UNITED STATES PATENT AND TRADEMARK OFFICE

APPLICATION NO.	FILING DATE	FIRST NAMED INVENTOR	ATTORNEY DOCKET NO.	CONFIRMATION NO.
10/667,644	09/22/2003	Hyun-Rok Cha	084017.22224	1116

Office Action Summary

DETAILED ACTION

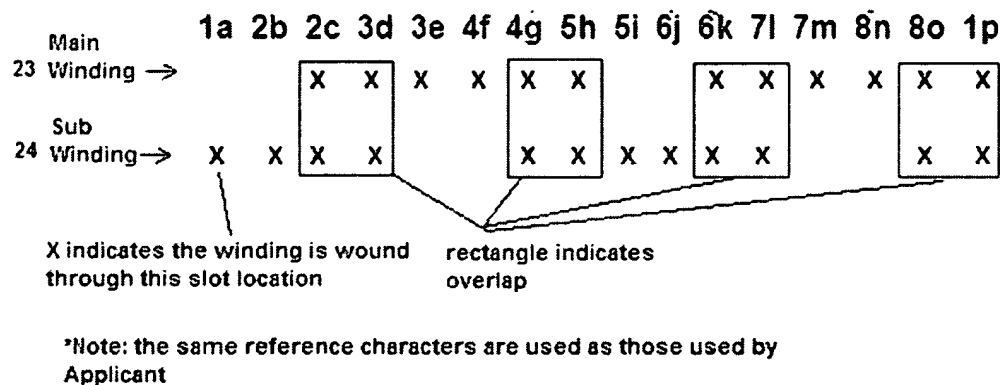
location of overlaps. For example, with respect to the embodiment of Fig. 11, the phrase "wherein at the four (4) slots" (as on page 12, line 16) is very unclear. One reading the specification would understand that windings 23 and 24 overlap in four of the slots. A more accurate interpretation would be that they overlap on four of the stator teeth (transitions from slot 2 to slot 3; 4 to 5, 6 to 7, and 8 to 1), as can be seen in the following figure. The other embodiments should be corrected as well.

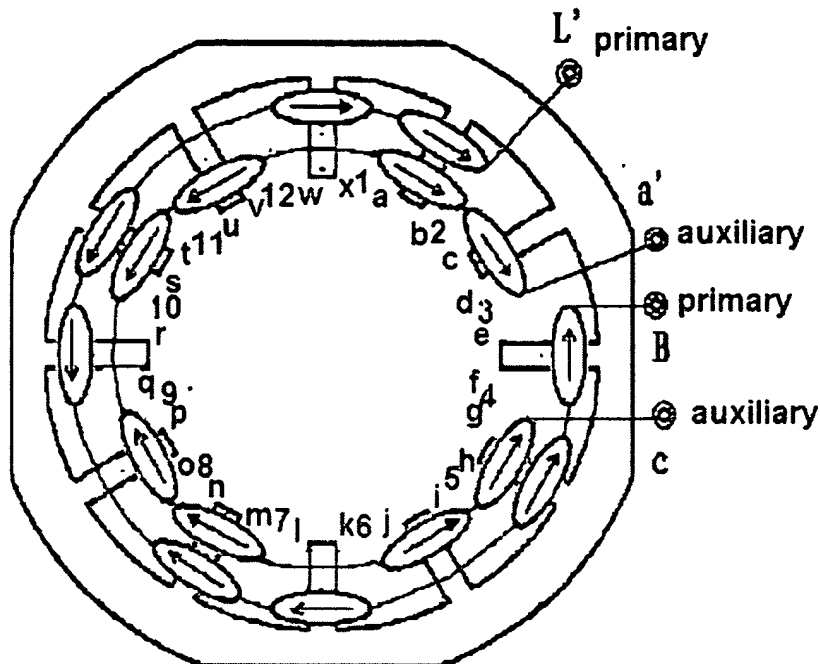
Regarding claims 1 and 2, Kenji et al. disclose winding a main winding (windings 7b, 7c, 7d, 7e, 7f, 7i, 7k, and 7l, and 7j in Fig. 2) and a sub winding (8a, 8c, 8d, 8f, 8g, 8i, 8j, 8l) through slots formed on a stator of a single phase induction motor, the main winding and the sub winding being wound with a regularity so that each is inserted into a predetermined slot and then is wound consecutively (i.e. without skipping any slots) through neighboring three (3) slots with reference to the initially entered slot, wherein at four stator slots, the main winding and the sub winding are overlapped. See the image below (based on Fig. 6).

The primary winding starts at slot 3 (3e) and is wound through the next three consecutive slots, i.e. 4f and 4g in slot 4, 5h in slot 5, and 6k in slot 6. The auxiliary winding starts at slot 4 (4g) and is wound through the next three consecutive slots, i.e. 5h and 5i in slot 5, 6j in slot 6, and 7m in slot 7. The two windings overlap on four of the stator teeth, i.e. the between 1a and 2b, the tooth between 4g and 5h, the tooth between 7m and 8n, and the tooth between 10s and 11t.

Regarding claims 3 and 4, Kenji et al. disclose inserting the main winding into a first slot 3 (3e) and is wound consecutively through seven other slots, i.e. slots 4 (f and 4g), 5 (5h), 6 (6k), 7 (7l and 7m), 8 (8n), 9 (9q), 10 (10r and 10s). The sub winding is inserted into a first slot 4 (4g), and is wound consecutively through seven other slots, i.e. slots 5 (5h and 5i), 6 (6j), 7 (7m), 8 (8n and 8o), 9 (9p), 10 (10s), and 11 (11t and 11u).

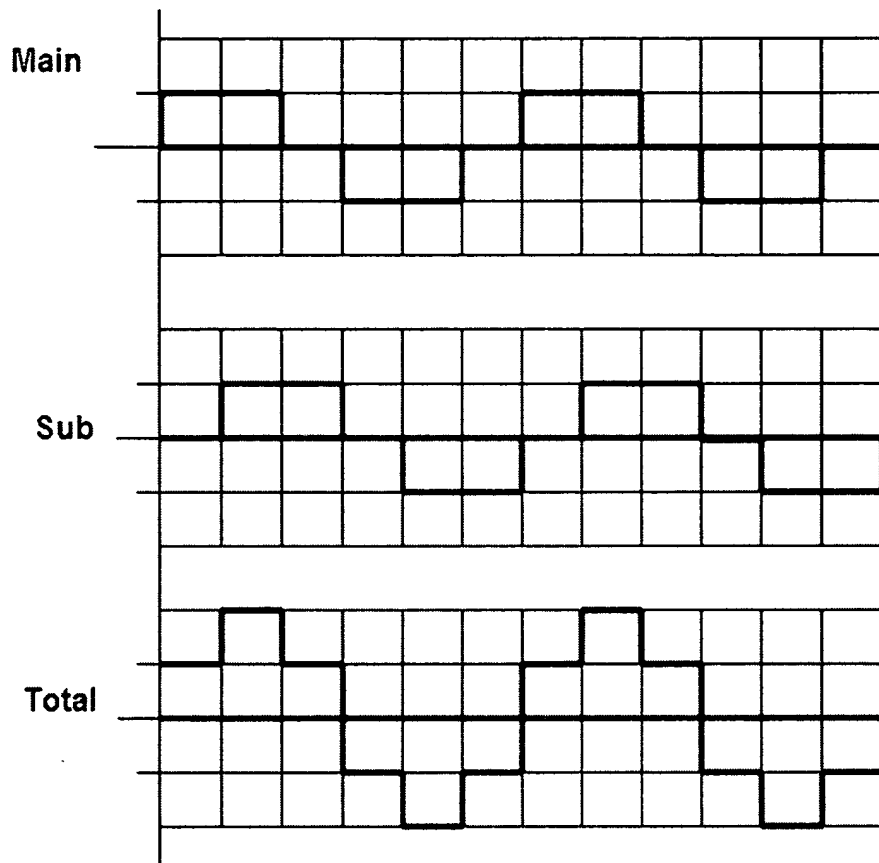
However, Kenji et al. disclose a winding arrangement which inherently results in a sinusoidal mmf waveform (see the image below).

“Main” illustrates a waveform produced by the main winding, “Sub” a waveform produced by the sub winding, and “Total” shows the net mmf waveform. As can be seen, the resultant waveform is sinusoidal, as in applicant’s invention.

At the time the invention was made, it would have been an obvious matter of design choice to a person of ordinary skill in the art to wind a stator core as in the invention claimed by the applicant because Applicant has not disclosed that winding the stator in the *particular* arrangement claimed in claim 3 provides an advantage, is useful for a particular purpose, or solves a stated problem that could not be solved by using a different winding pattern. Passing a winding through N slots before skipping a stator tooth, as opposed to say N+1 or N-1 affects the shape of the waveform, but maintains
